3 West Lenox Street (Prelim.)  
(Chevy Chase Village HD)

**HISTORIC PRESERVATION COMMISSION STAFF REPORT**

<b>Address:</b>	3 West Lenox Street	<b>Meeting Date:</b>	03/14/01
<b>Applicant:</b>	Bill & Judy Munn (Ron Brasher, Architect)	<b>Report Date:</b>	03/07/01
<b>Resource:</b>	Chevy Chase Village Historic District	<b>Public Notice:</b>	02/28/01
<b>Review:</b>	HAWP	<b>Tax Credit:</b>	Partial
<b>Case Number:</b>	35/13-01C	<b>Staff:</b>	Perry Kapsch

**PROPOSAL:** Rear addition, side deck, lower level garage.

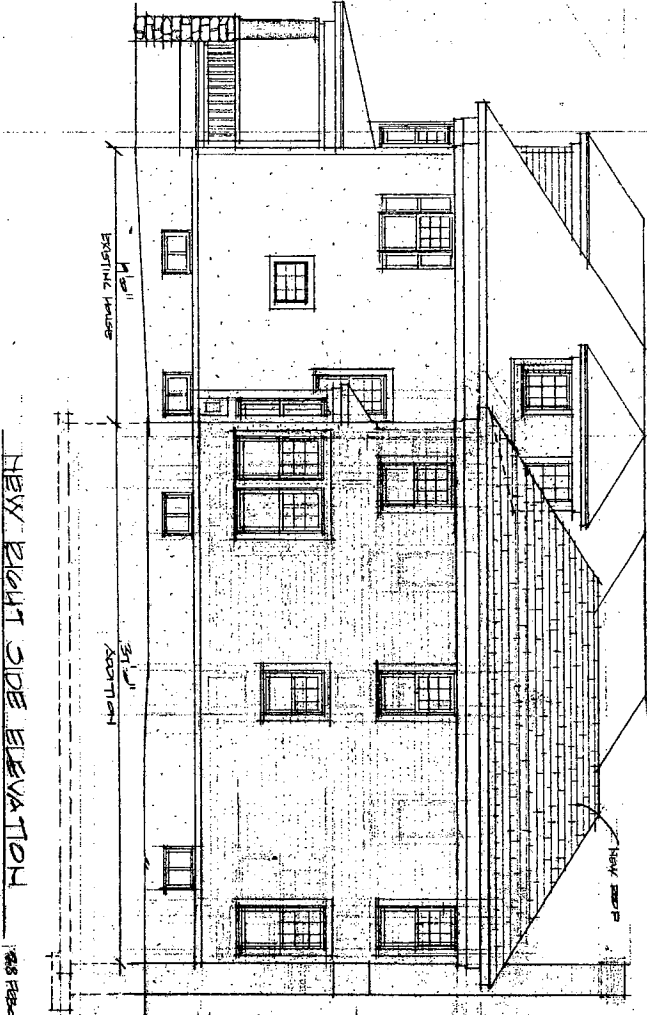
PERRY - THE MUNNS HAVE MADE A SLIGHT CHANGE  
SINCE THEY HAVE LIVED IN THE HOUSE FOR A WEEK.  
THEY WANT TO ADD A STUDY ABOVE THE LIBRARY  
ADDITION ON THE FIRST FLOOR. I MADE IT A FLAT  
ROOF TO LOOK LIKE THE PORCH. IT WORKS!

NEW RIGHT SIDE ELEVATION

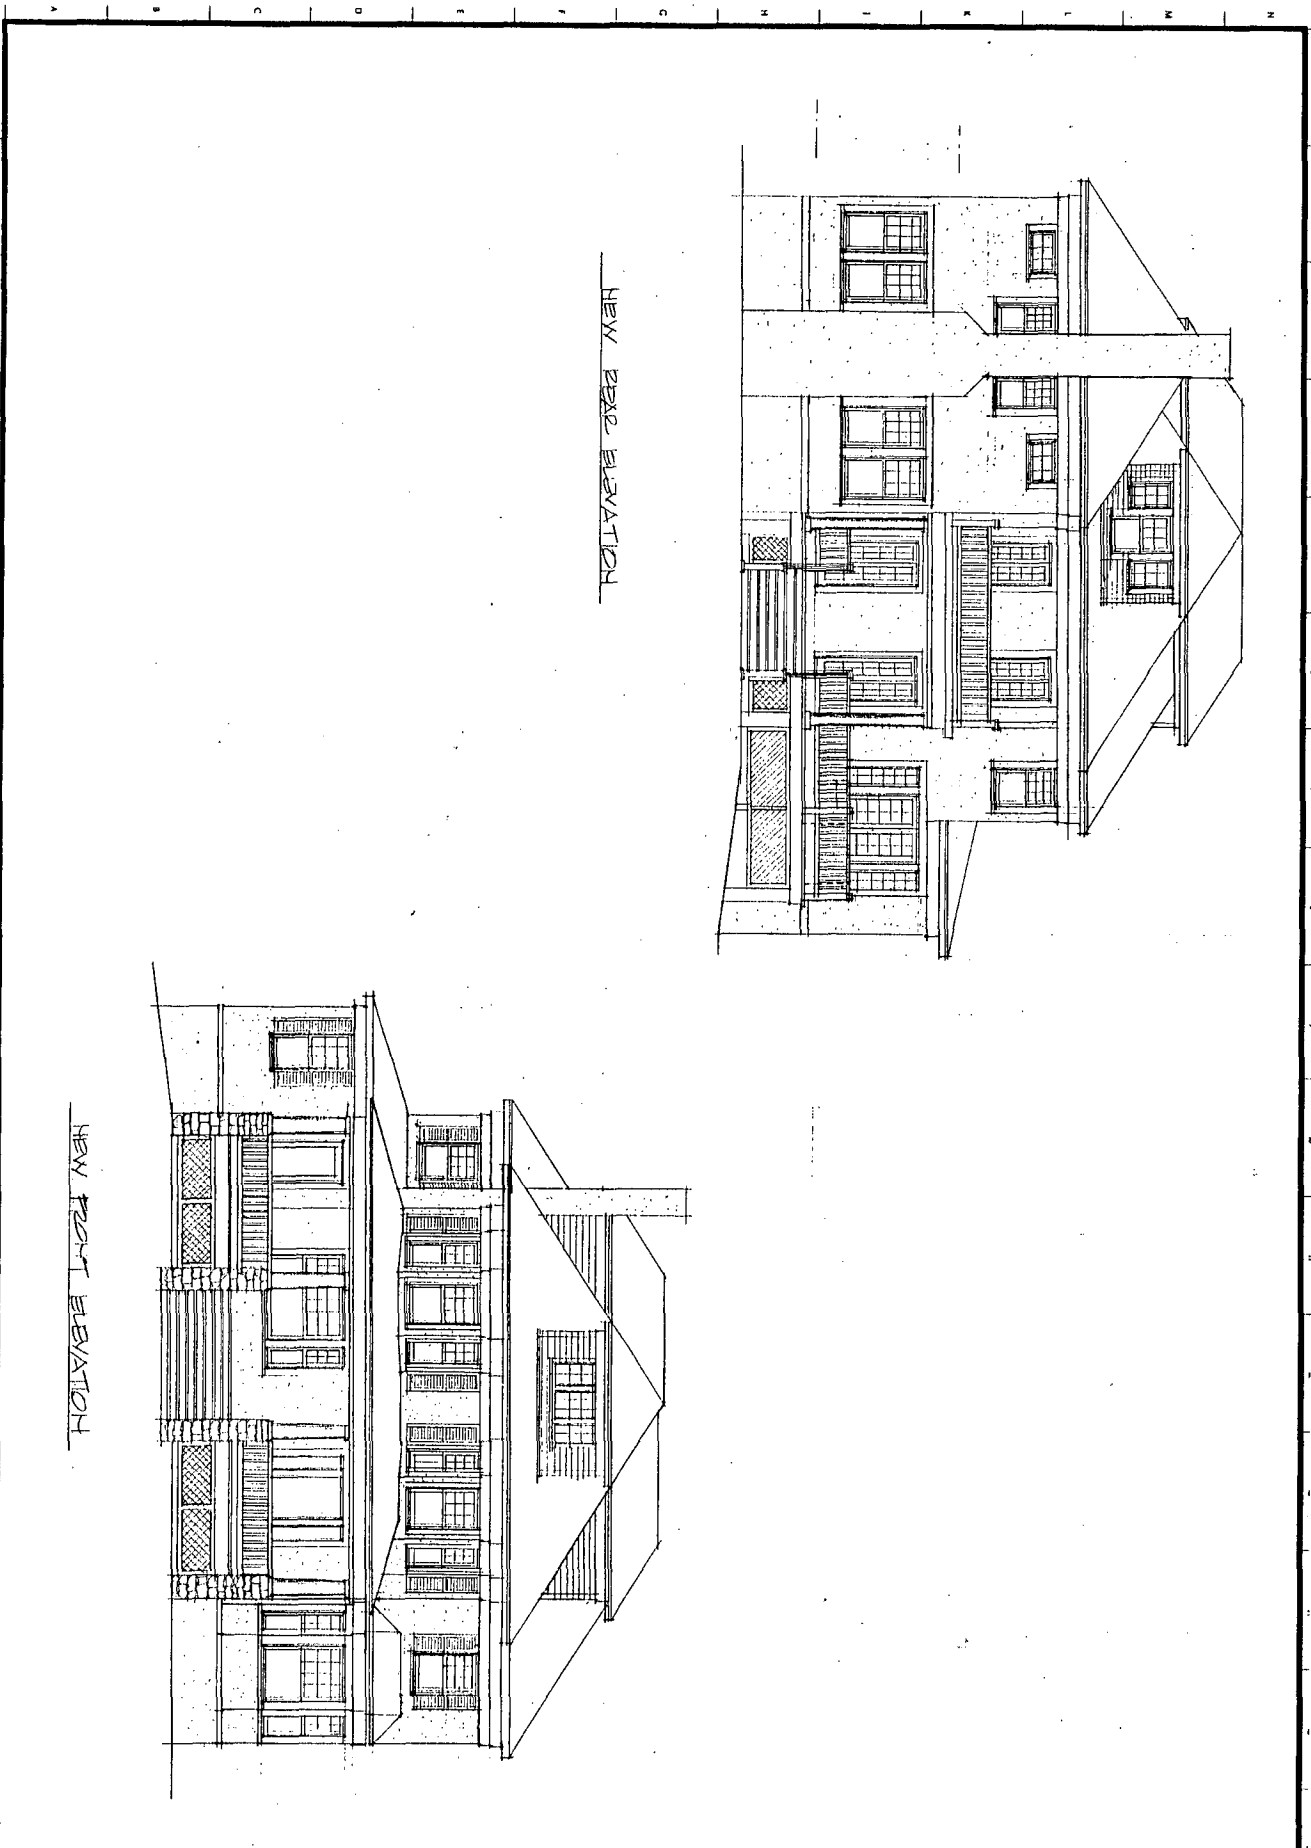
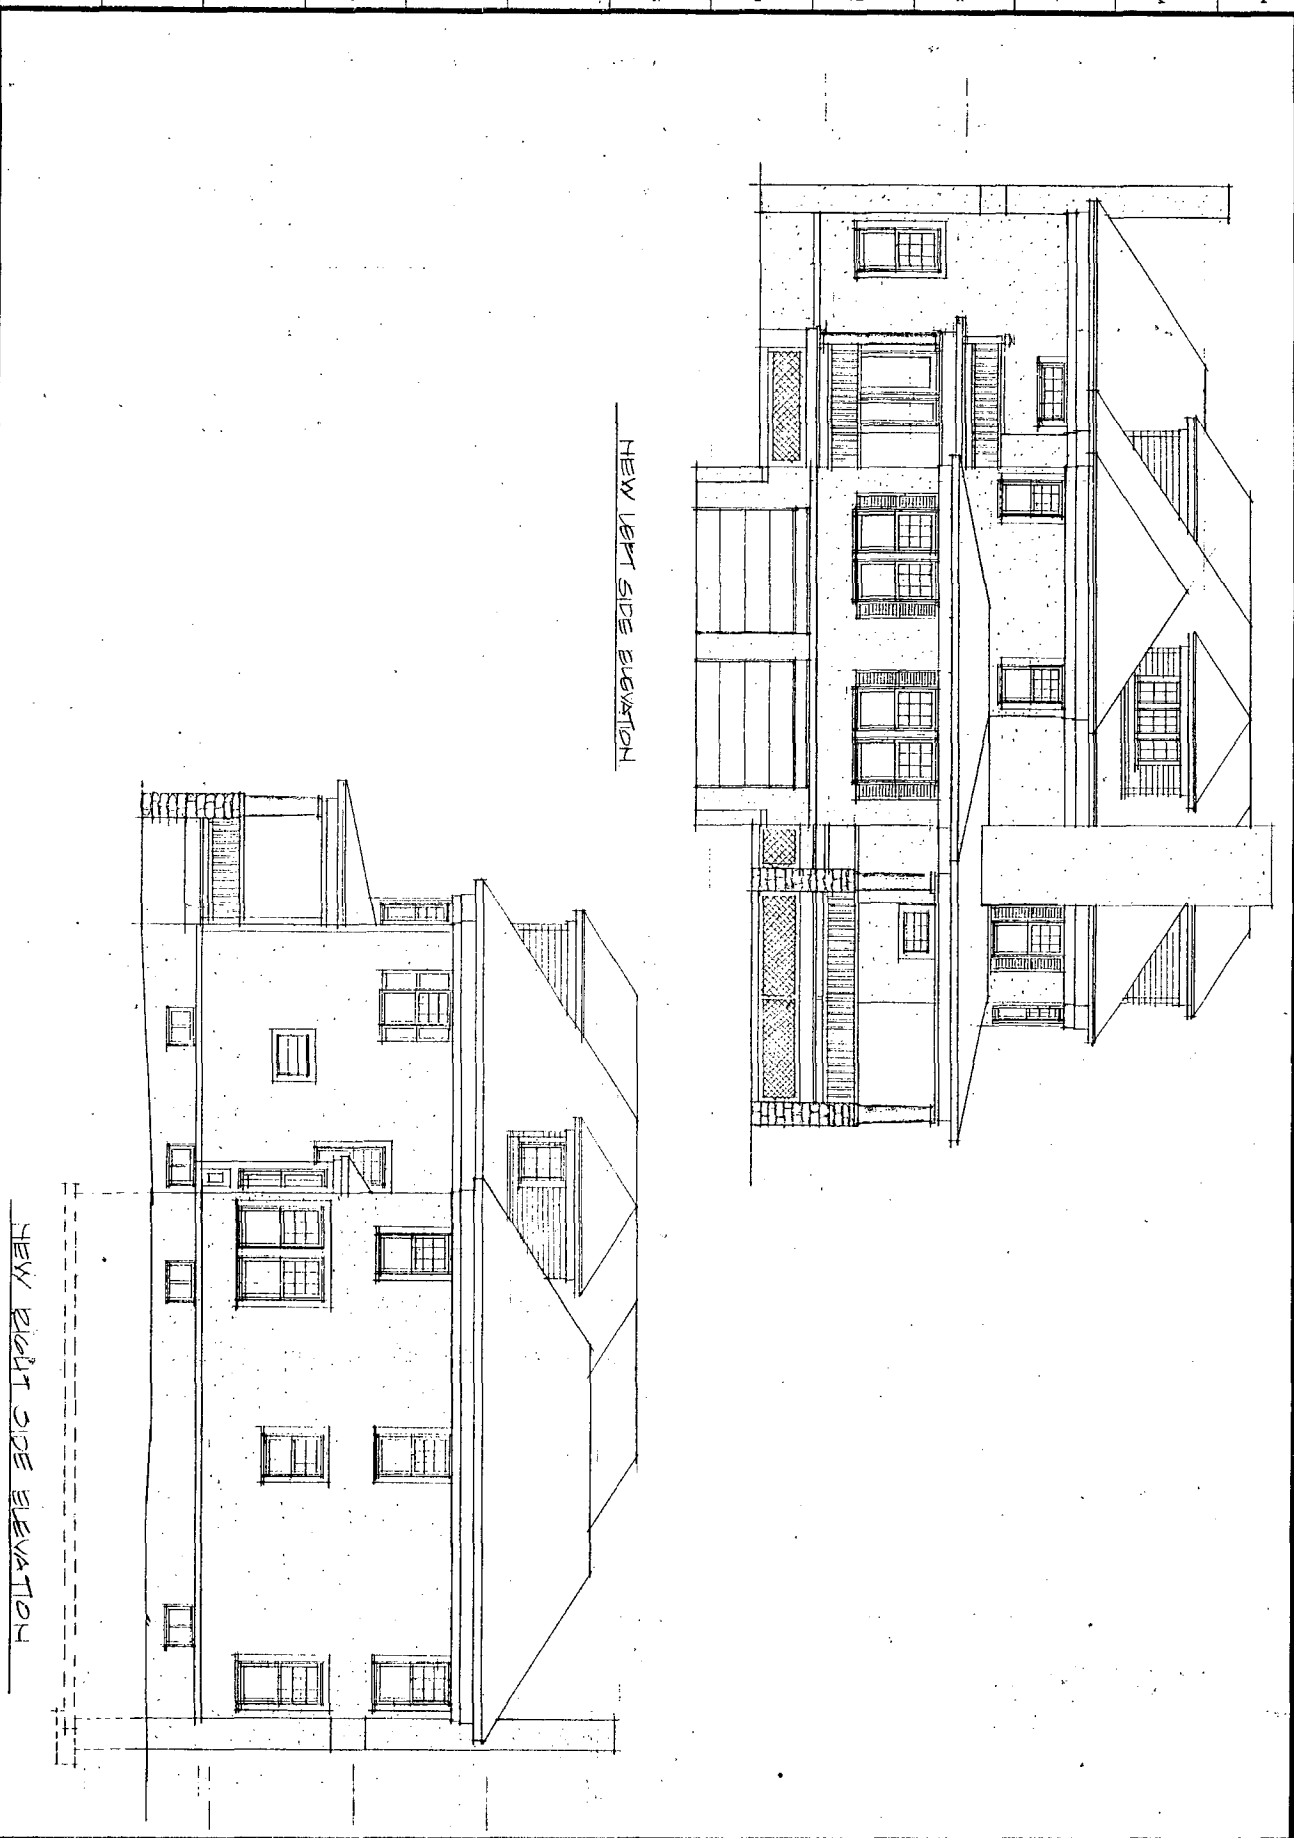
resp. garage is set so far back.

EQ = worried about loss of bay.  
→ the smallness of the proposed  
left side.

AR - don't retain 4 sq.  
down rose bay.

1. asked to modify left side change -
  2. not maximization as in su. Just trying to get useable space.
  3. don't want street parking
  4. have elevator - need handicapped access for elderly parents.
- don't want to see garage doors from street - can use a beam

DH - agree w/ claim that remaining issue is 1st flt above garage -  
1) sig Δ appearance of house - no.  
2) concerned that w/g garage creates well

OK. garage should be @ grade  
both added
